**RECORD OF DECISION  
WEST CENTRAL PHOENIX – NORTH PLUME  
WQARF REGISTRY SITE  
PHOENIX, ARIZONA**

November 6, 2019

**PROPOSED REMEDIAL ACTION PLAN COMMENTS**

**Figure 6**  
**ERD Groundwater**  
**Treatment System Layout**  
**WCP – North Plume WQARF Site**  
**Phoenix, AZ**

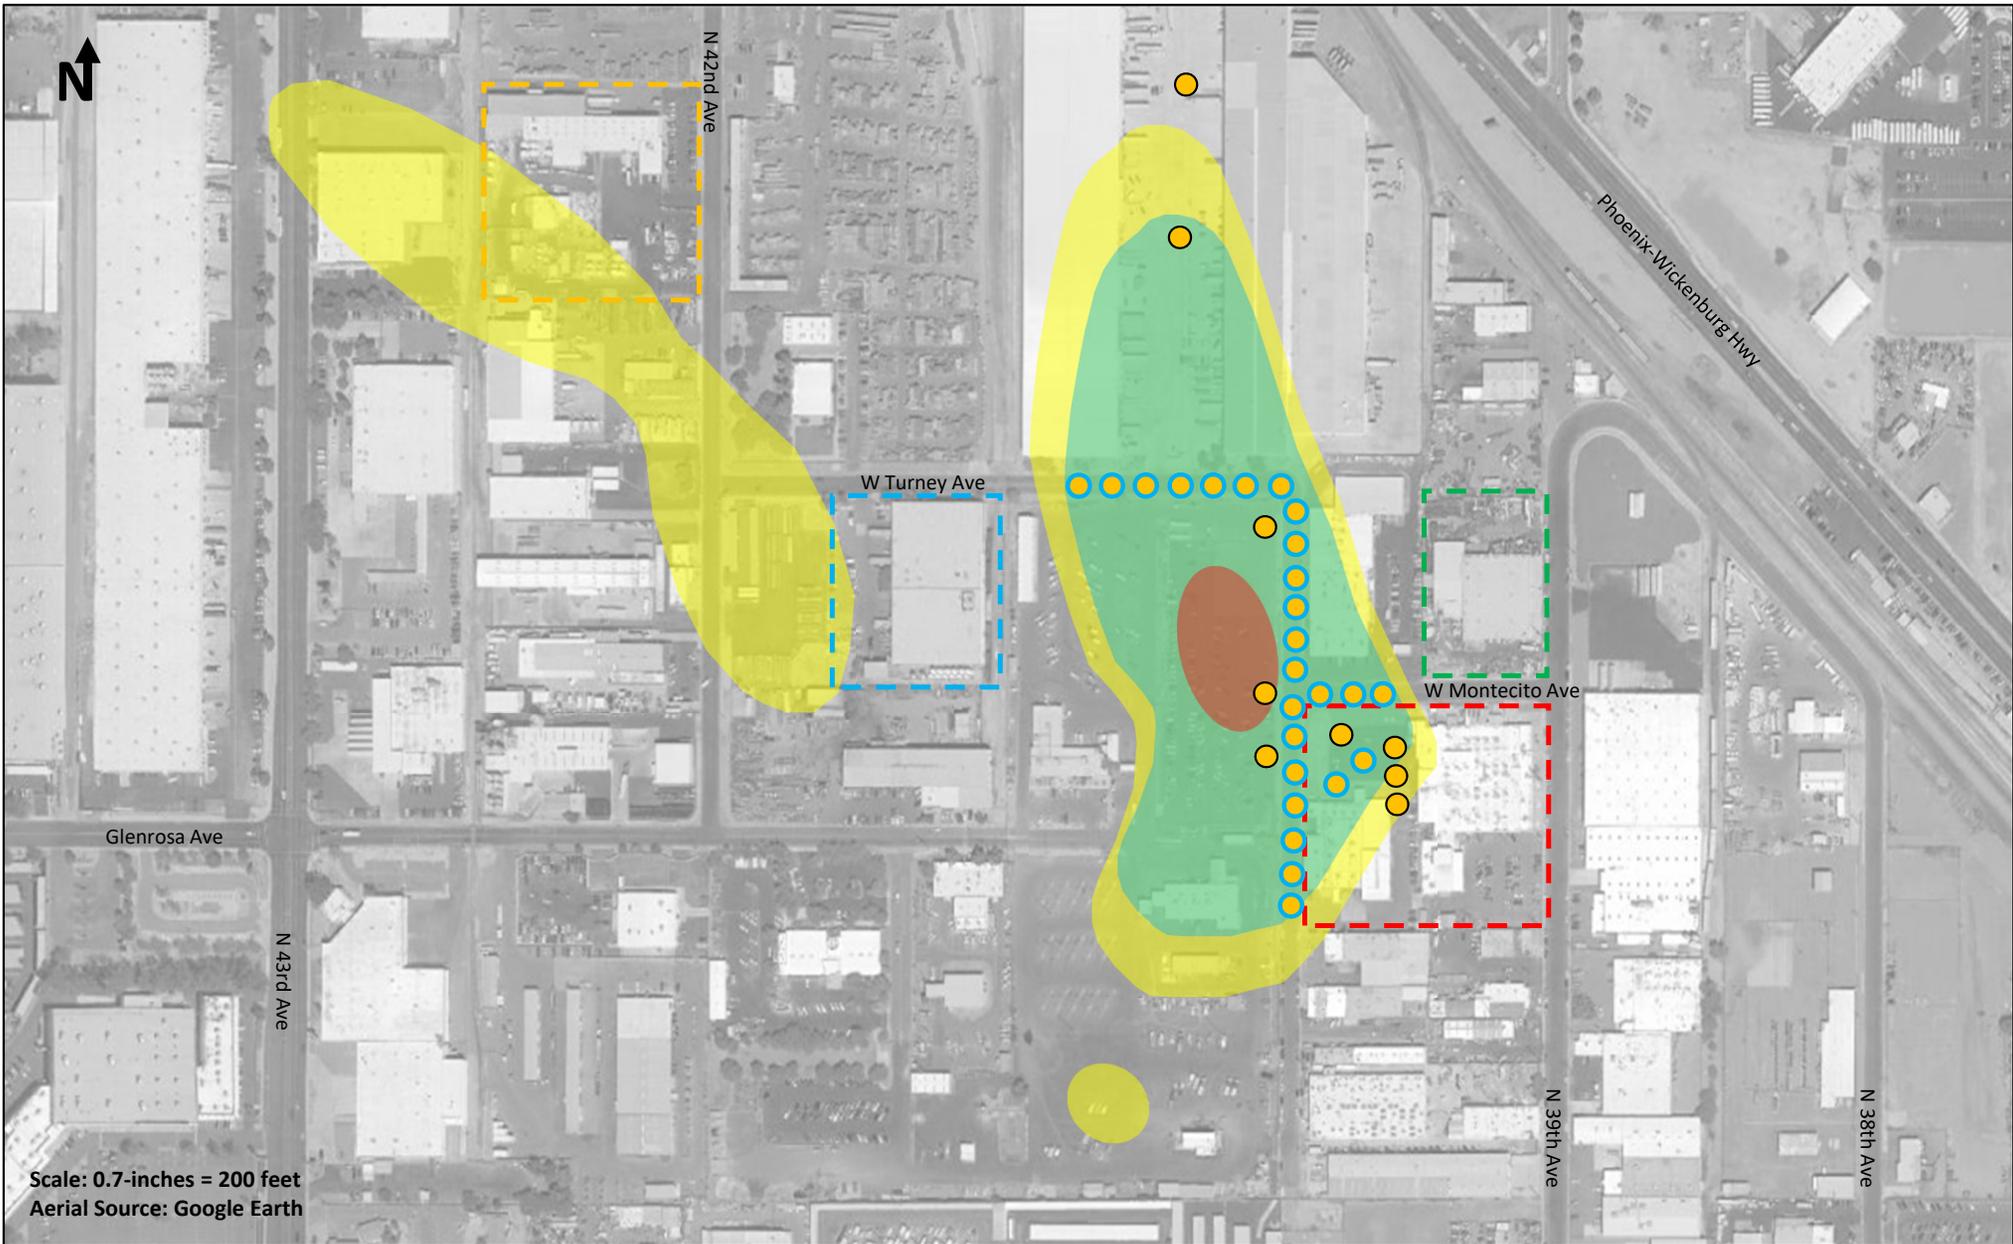
The City recommends the ERD system be expanded into the portions of the plume with values of 100 µg/L to 1000 µg/L of PCE; not just the area above 1000 µg/L as currently stated (see figure 5-2).

ADEQ concurs with the comment. The area of the plume to be treated with in-situ ERD injections has been revised in the ROD. The area of the plume to be treated with in-situ ERD injections includes the area of the plume within the 100 ug/L PCE iso-concentration contour line.
